Review 1

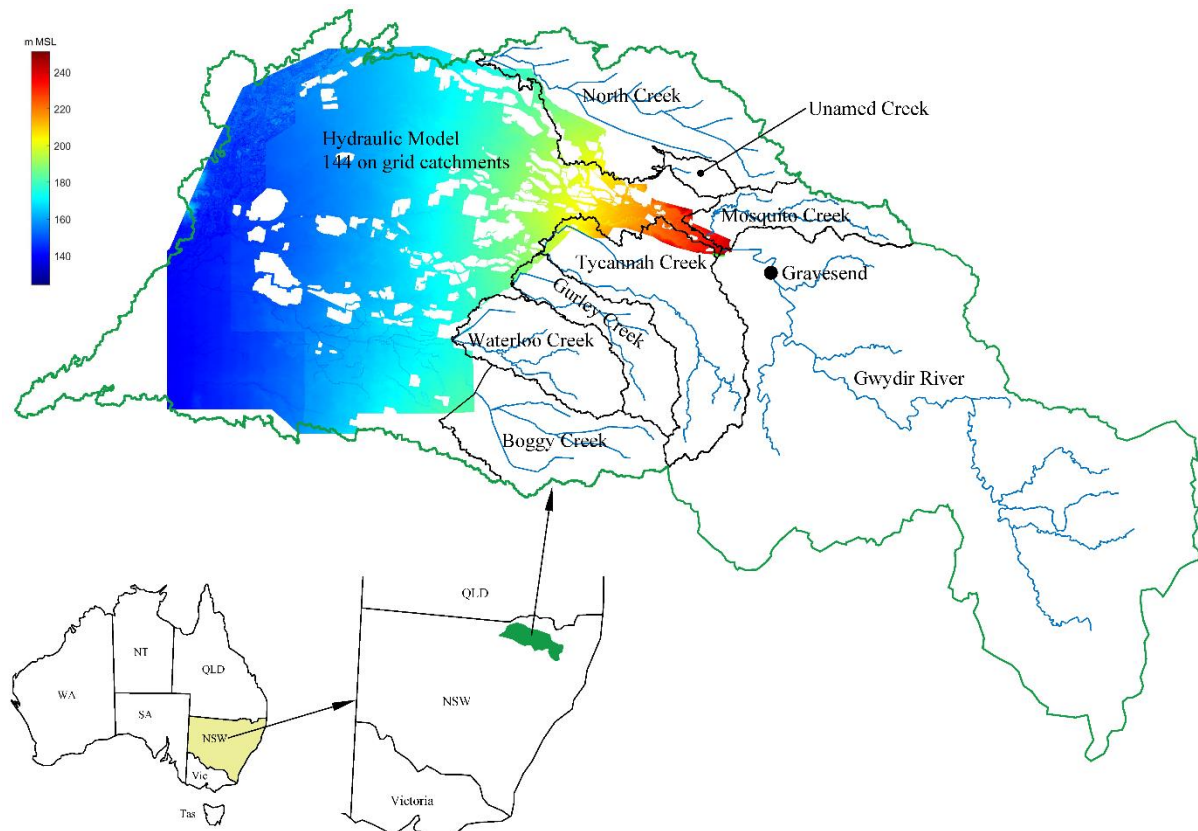
Figure 2. The colours of the bathymetry and the associated colour bar have me believing that the catchment is stepped.

Changed colour scheme to remove stepped appearance. New figure is now

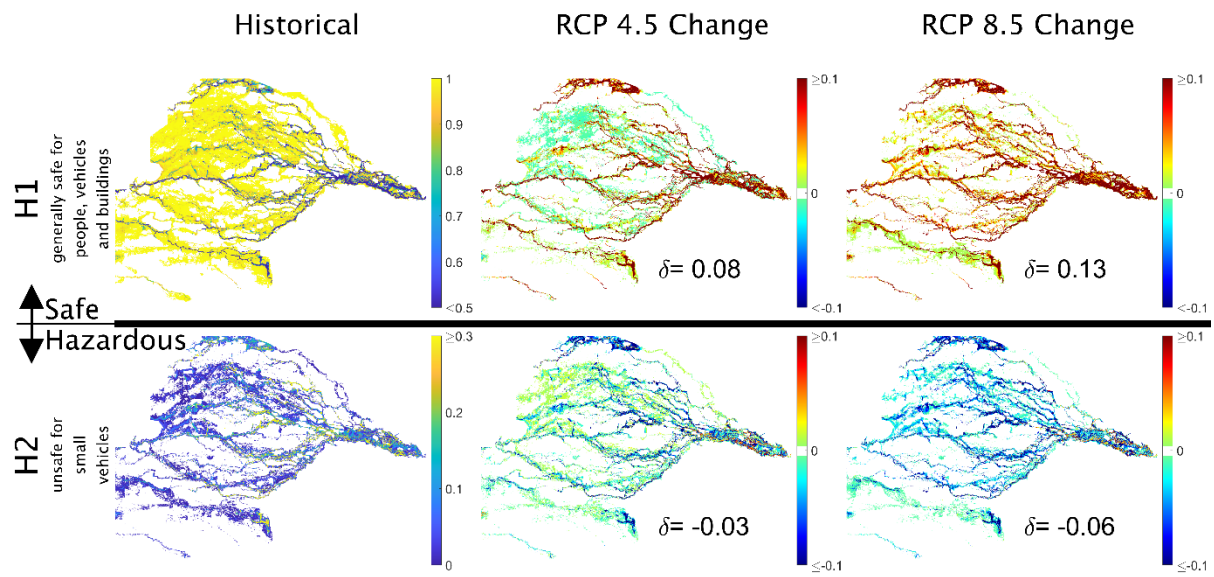
Figure 5 & 6. Wherever differences are plotted, I like the colour scheme to centre around white, with +ve value an increasing shade of red and -ve values a decreasing shade of blue, otherwise it is rather ambiguous.

The colour scheme was changed as suggested, e.g.,
